**Concurrence Point 3
Preferred Alternative Selection (LEDPA)**
and

**Concurrence Point 4A
Avoidance and Minimization**

TIP Project No. R-5808
WBS 46972.1.1

U.S. Route 158 Improvements
From Acorn Hill Road (S.R. 1002) to the Pasquotank County Line
Gates County

Exhibit 5. Alternative 1 Construction Methods and Undercut/Backfill Areas

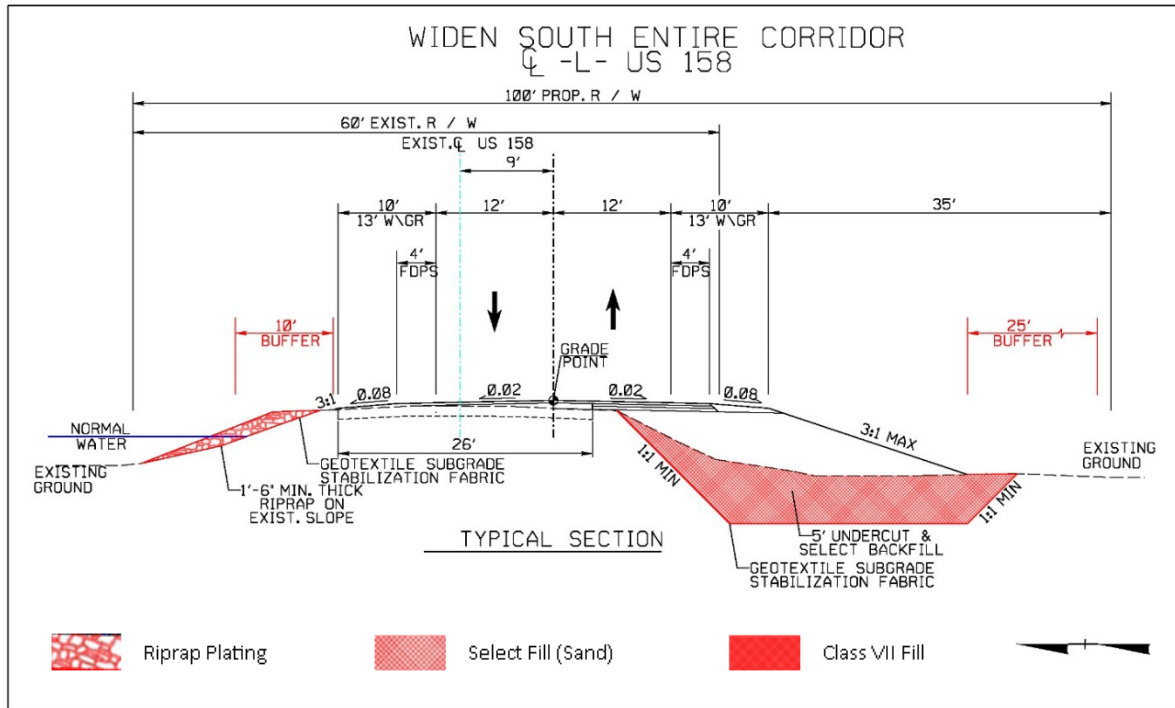
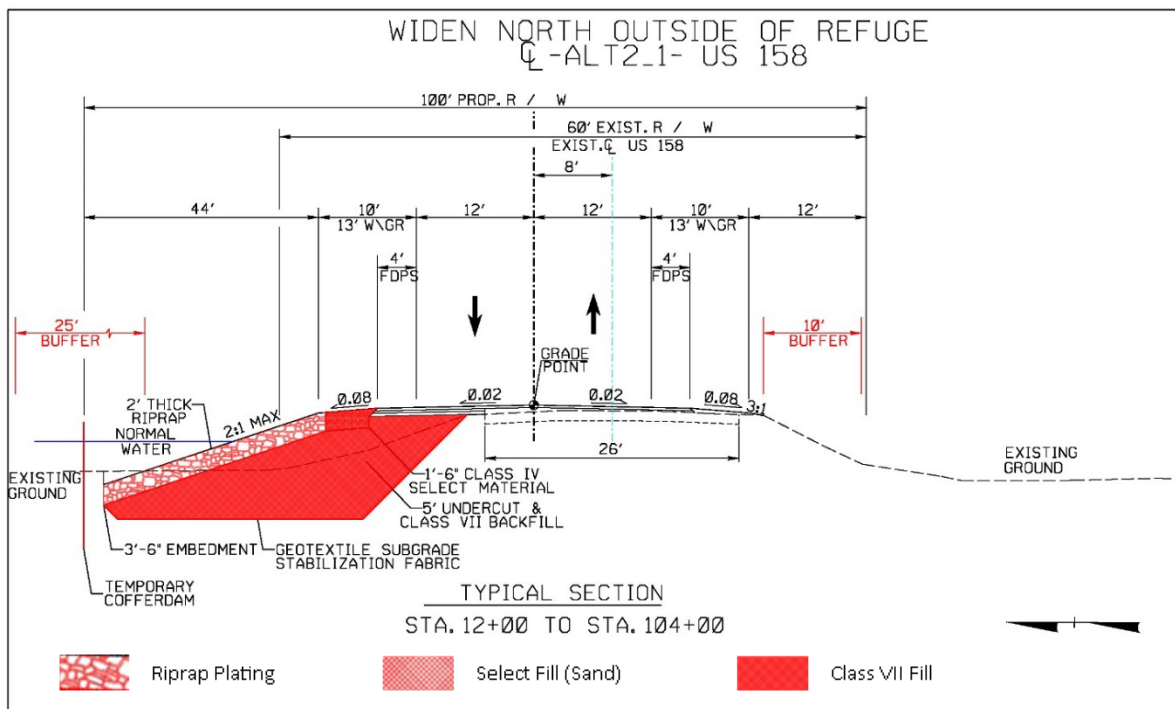
Amanetta said she did not believe there was enough of a difference in construction duration between Alternatives 1 and 2 to make Alternative 2 impracticable. Amanetta said that the US Environmental Protection Agency (USEPA) will wait to provide concurrence on the LEDPA until USACE is more comfortable with the LEDPA decision.

Kyle said he believes there is some additional room for discussion regarding constructability, the difference in cost, and potential for reduction in impacts, as compared to the assumptions made, and may want to see more detail or information regarding that. Teresa said that although a higher level of detail for construction costs and methods is typically not available at this point in the Merger process, the project team has done a brief calculation of impacts based on slope stakes only (without a buffer). This calculation indicated that although Alternative 1 would still be anticipated to have more wetland impacts than Alternative 2, that difference would be about half of the difference when comparing the impacts calculated with a buffer.

Based on the preliminary design and the limits of the delineated open water, eight individual cofferdams are anticipated to be required for construction of Alternative 2. No dewatering or cofferdams are anticipated to be required in Alternative 1. To comply with the work zone traffic control safety guidelines, the cofferdams would be no longer than 200 feet in length. The area needing to be dewatered is approximately 1,600 linear feet in length and covers an approximately 0.6-acre area.

Both Alternative 1 and 2 are anticipated to require the undercut and replacement of existing material with suitable material. The difference between the two alternatives is in the type of suitable material which will be needed. In Alternative 1, the undercut operation would result in a confined space that could be filled with select material, anticipated to be a sand gradation soil in this area (see **Exhibit 5**). Since Alternative 2 would conduct some of the undercut and backfill operations in open water areas which would not be confined, a Class VII Material would be required (see **Exhibit 6**). This material is specified to consist at least 50% of blasted rock material with a diameter of 1.5 to 3 feet, 30% with a diameter of 2 inches to 1.5 feet, and less than 20% of the material with a diameter less than 2 inches. This material

would have an approximate cost of \$145 per cubic yard. This material would not be able to be sourced locally like the select material and is anticipated to require trucking from the nearest quarry in Sims, Wilson County, approximately 125 miles away.

Considering the addition of dewatering procedures and backfill with Class VII material to the construction methods of Alternative 2, as compared to Alternative 1, it is anticipated to increase the duration of construction by at least twelve months and the cost by 20%. Construction duration is of particular concern because US 158 is a designated hurricane evacuation route. Increased construction duration of twelve months would span up to two additional hurricane seasons over which construction could reduce evacuation efficiency.

Figure 1. Rock Embankment Construction - Typical Section

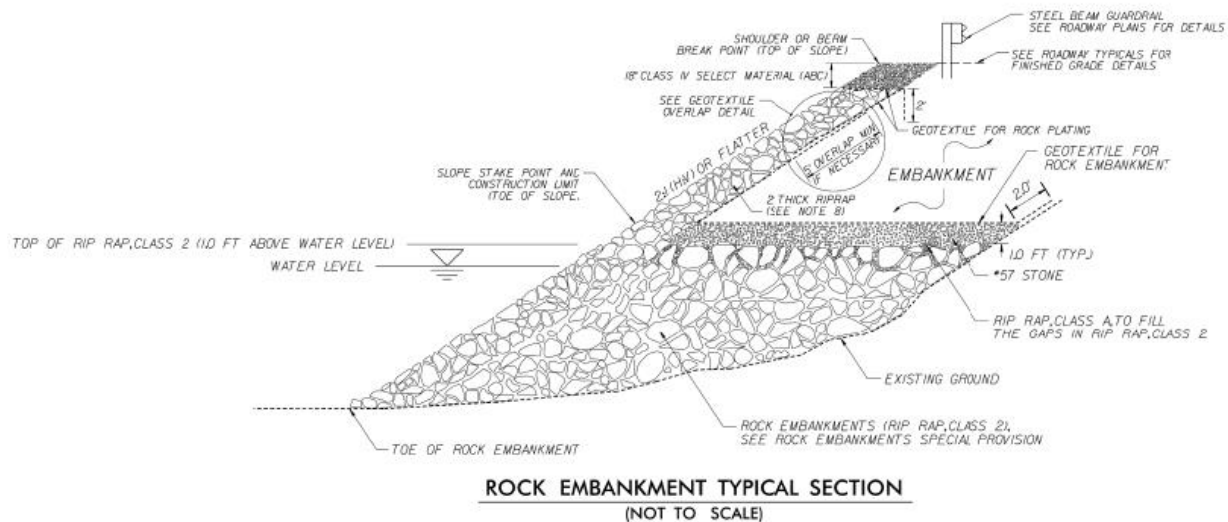
Kyle Barnes believed there was some additional room for discussion regarding constructability concerns, refined cost differences, and refined impact projections, as compared to the assumptions made and presented at the CP3 meeting. NCDOT needs to show that Alternative 2 is not practicable, as defined by the 404(b)(1) guidelines which state – “The term practicable means available and capable of being done after taking into consideration cost, existing technology, and logistics in light of overall project purposes.” The following discussion and information attempts to provide more information on these parameters without proceeding too far into the design process.

Discussion of additional construction costs between Alternatives 1, 2, and 3 offered at the CP 3 meeting was based on some assumptions by KHA staff, which considered cofferdam installation and associated monthly operational costs, as well as the additional traffic control these construction methods would require. Stephen Holland (KHA) outlined the proposed procedure for dewatering during construction of Alternative 2. Cofferdams are proposed to be used to remove water within the proposed construction limits. Approximately eight (8) individual cofferdams will be needed to comply with the work zone traffic control safety guidelines, which dictate the distance between automatic flagger traffic control devices shall be placed no more than 200 feet apart. The area needing to be dewatered is approximately 1,600 linear feet in length and covers an approximately 0.6-acre area. The dewatering process is the main reason why the construction of Alternative 2 is anticipated to take approximately nine (9) months longer than Alternative 1. This yielded an approximate 10% increase in construction costs of Alternative 2 over Alternative 1. Further comparison of potential construction methods detailed below indicate that the overall resultant estimated increase in cost for Alternative 2 over Alternative 1 is likely over 20% more, and additional construction time will be twelve (12) months. Construction duration is of particular concern because US 158 is a designated hurricane evacuation route. Increased construction durations of nine to twelve months could mean one or even two additional hurricane seasons over which construction could reduce evacuation efficiency.

Consultation with NCDOT's Geotechnical Unit and Division 1 construction personnel reveals that construction in open water areas of Alternative 2 will involve undercutting and the replacement of undercut material with Class VII select material to a level 1.0 foot above the normal standing water elevation (see Figure 1., a typical section from another project that used Class 2 riprap instead of Class VII). Regulatory agencies will also require NCDOT's Division 1 to place geotechnical fabric under the rock embankment.

With an approximate cost of \$145/CY (cubic yard) for Class VII material, and approximately 2CY per foot of embankment as shown above (assume an average 15 feet embankment width and average 7 feet embankment thickness), this would add approximately \$0.5M to the cost of Alternative 2. Once the fabric is in place the construction is similar to placing a soil embankment, but it is about 1.5 times slower due to the increased trucking. The legal load volume for each truck carrying stone is less than if it was carrying soil. The increase in time and subsequent impact to project schedule would be more likely 12+ months versus the previously discussed 9 months. Additionally, Class VII material, needed to construct the embankment in the open water sections of Alternative 2, would likely be sourced from Sims, in Wilson County, NC, located approximately 115 road miles from the project site. The lack of rock in the coastal plain of NC, suitable for embankment construction, is a primary reason that this construction method is rarely used in Division 1.
